**19 Park Village West
London NW1**

ARBORICULTURAL INSPECTION REPORT

TMC Ref: 11058R

Title: London Plane Tree & Boundary Wall
Sections

³ RG1 - Section - Wall movement

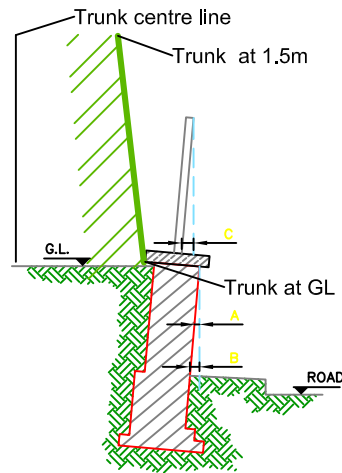
- 3.1 I have seen the various plans and photographs indicating damage to the boundary wall. Appended as RG1 is an extract of the engineer's drawings which show the trunk of the London plane tree and displacement of the boundary wall³. Clearly the growth of the trunk and, I suspect, roots on the inside of the wall, are causing this displacement. Furthermore, I would be surprised if the footings of the wall have not been damaged and lifted by the tree's roots. In the same way the corner pier has also been damaged by the tree's trunk and roots.

TYP. SECTION THRU' PROPOSED PERIMETER WALL

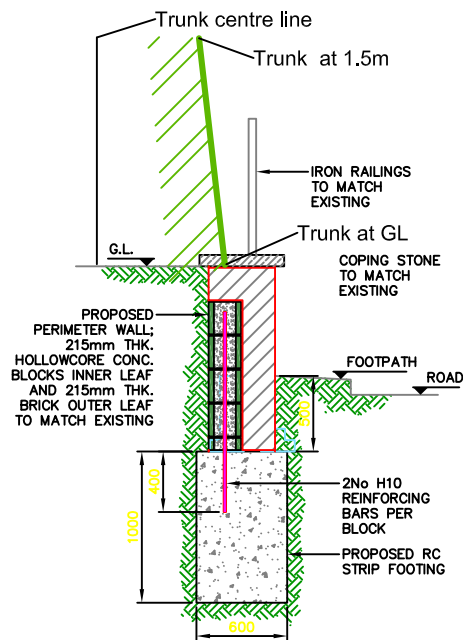
- 3.2 I note that if the wall is to be restored it would be rebuilt on the boundary as indicated on the engineer's plans. On an extract of this plan⁴ I have indicated the dimensions of the trunk at ground level within the garden. This shows that the wall cannot be rebuilt in its current location without cutting into the trunk and main roots running down the inside of the wall. The same applies to the corner pier.

- 3.3 Furthermore, the additional depth of foundation and reinforcement would sever any anchorage roots crossing below the existing footing and into the surrounding highway. Deciduous trees support themselves in tension and this tree is exposed to the southwest. The roots under the wall are therefore vitally important in maintaining the tree's stability. Indeed, field studies⁵ have shown that even for trees of 85cm trunk diameter the minimum root plate radius should be some 3 - 4 metres to maintain stability.

- 3.4 In the event of the wall and pier being reconstructed further from the trunk, it would need to be at least 1 meter from the base of the trunk to allow for the increasing girth and buttress root expansion. In this event, any major root would need to be bridged by the footings to maintain the tree's stability.
